Norwich to Tilbury

Document: 8.26 Response to Rule 17 Letter received 5th June 2026

Planning Inspectorate Reference: EN020027

Drawing Number:	10059280-ARC-EGN-ZZ-DR-ZZ-00937	Revision:	A
-----------------	---------------------------------	-----------	---

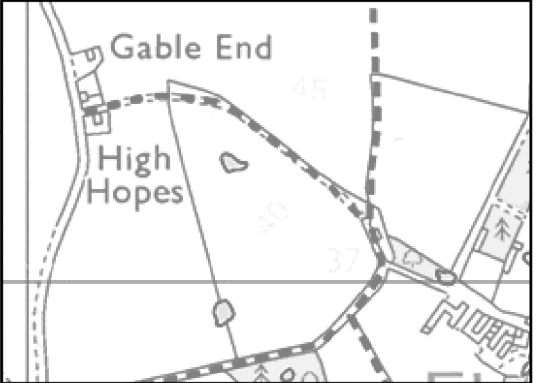
3.1.1 *'At the Accompanied Site Inspection on Wednesday 27 May 2026 the ExA noted the proximity of cottages 70, 71 and High Hopes, Flordon Road (postal address Norwich Road, Flordon, NR15 1RU) to the Order Limits and their relationship with 72 and 73 Flordon Hall Cottages NR15 1RT. These properties have not been assessed in the Residential Visual Amenity Assessment [REP4-148]. The ExA requests an assessment of these properties.'*

3.2.3 As shown on drawing 10059280-ARC-EGN-ZZ-DR-ZZ-00937 - 8.26 Response to Rule 17 Letter received 5 June 2026 - Residential Visual Amenity Assessment - 70, 71 and High Hopes, Flordon Road, in Appendix A, the individual curtilage of all three of these residential properties lie outside of the 200 m Study Area. The closest point within the curtilage of 'High Hopes' is 208 m from centre line of the permanent above ground elements of the Project. The corresponding closest part of the curtilage of cottage '70' is 258 m, and for cottage '71' it is 245 m. Consequently, these properties were not included in the **RVAA [REP4-148]** at submission.
